Building Downwash Modeling with AERMOD

Lloyd L. Schulman and Joseph S. Scire
Exponent, Inc.

10th Conference on Air Quality Modeling
March 15, 2012

Case Analysis to Illustrate Problem with Change to AERMOD

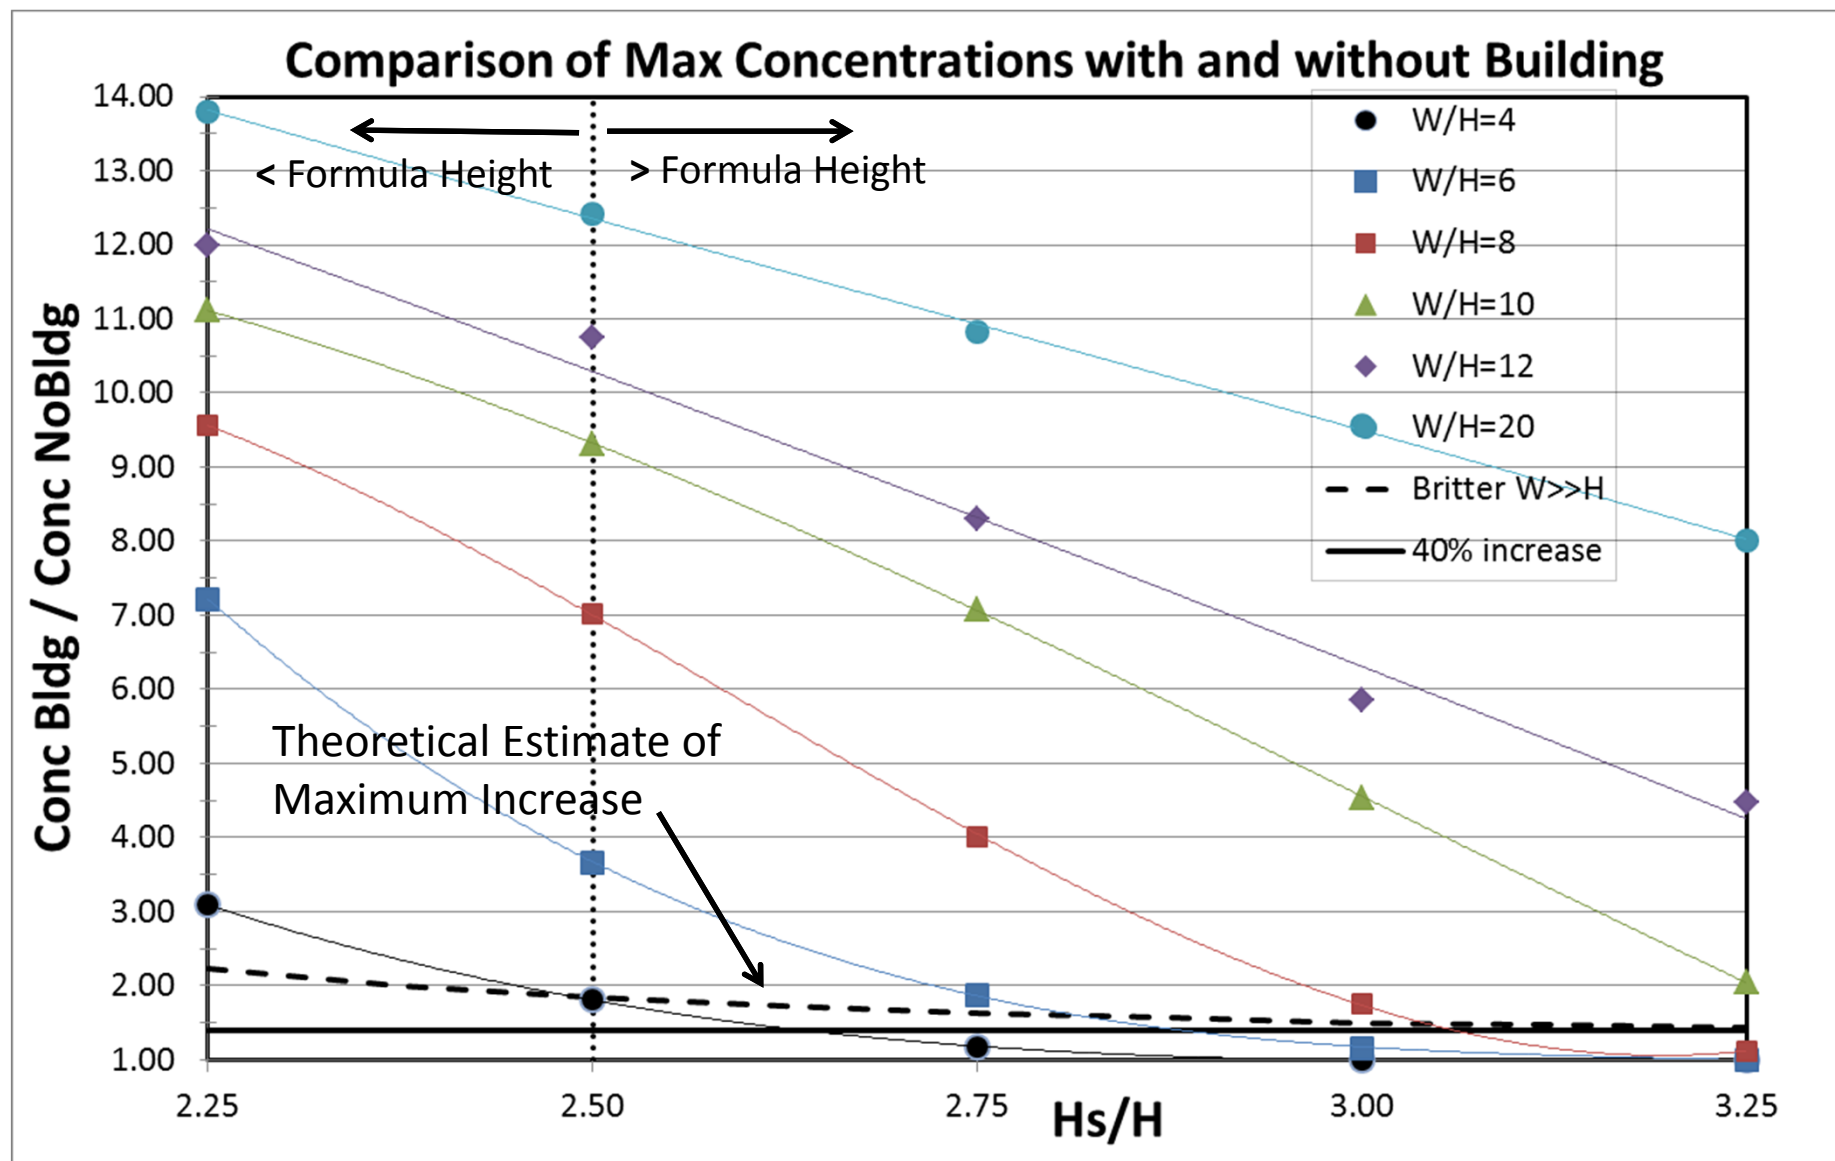
Ratio of max concentrations with and without buildings are all below the 40% increase for stack heights $\geq$ formula height and $W/H \leq 3$

Ratio of max concentrations with and without buildings are mostly above the theoretical estimate of increase for stack heights $\geq$ formula height and $W/H \geq 6$; Before code change the ratio would have been 1 for stacks $\geq$ formula height

Observed v. Predicted Q-Q Plots – 1977 (1-hr Average SO₂ Concentrations)

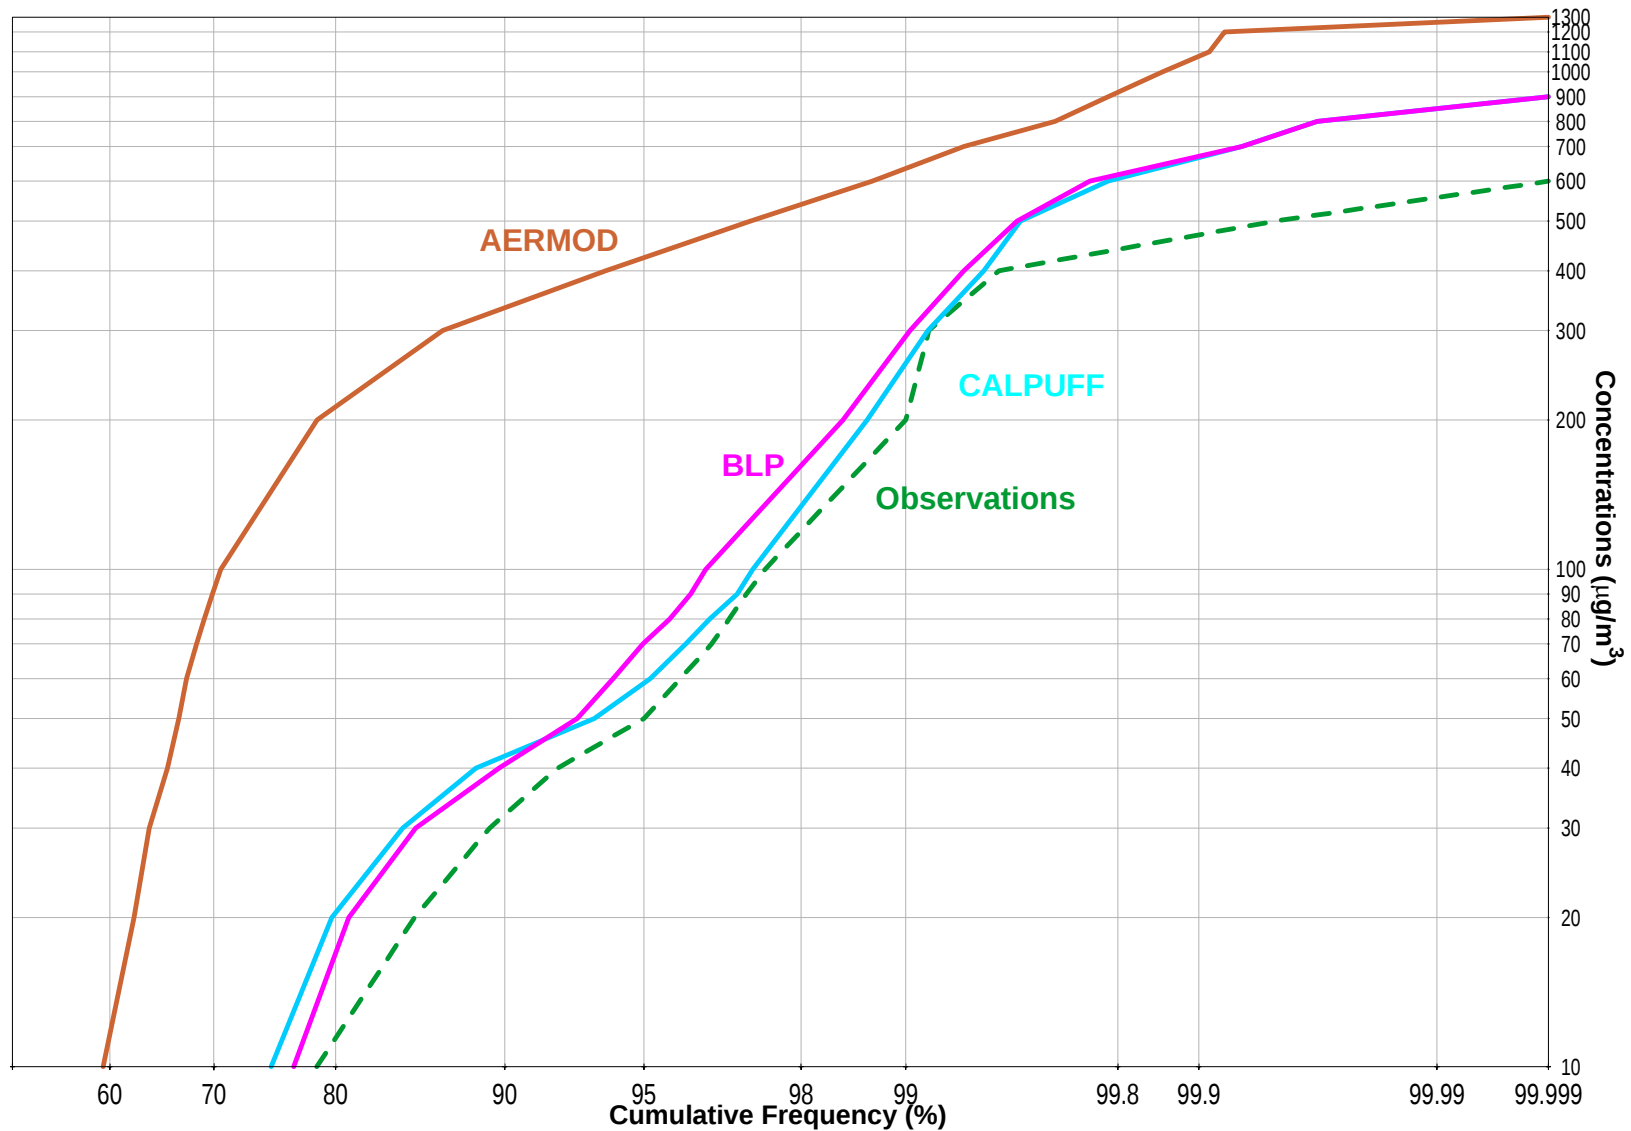
- AERMOD significantly over-predicted building downwash impacts of point sources (stacks) for very wide buildings
 - Potroom W/H of 10 – 25 are common
 - Over-prediction of observations by a factor of 10 or more on annual averages
 - Over-prediction of observations of factor of 2-10 on short-term (1-hr) averages
- BLP algorithms (in BLP or CALPUFF) perform well relative to observations
- EPA should allow Section 3.2 Petitions (use of alternative models) for this type of application
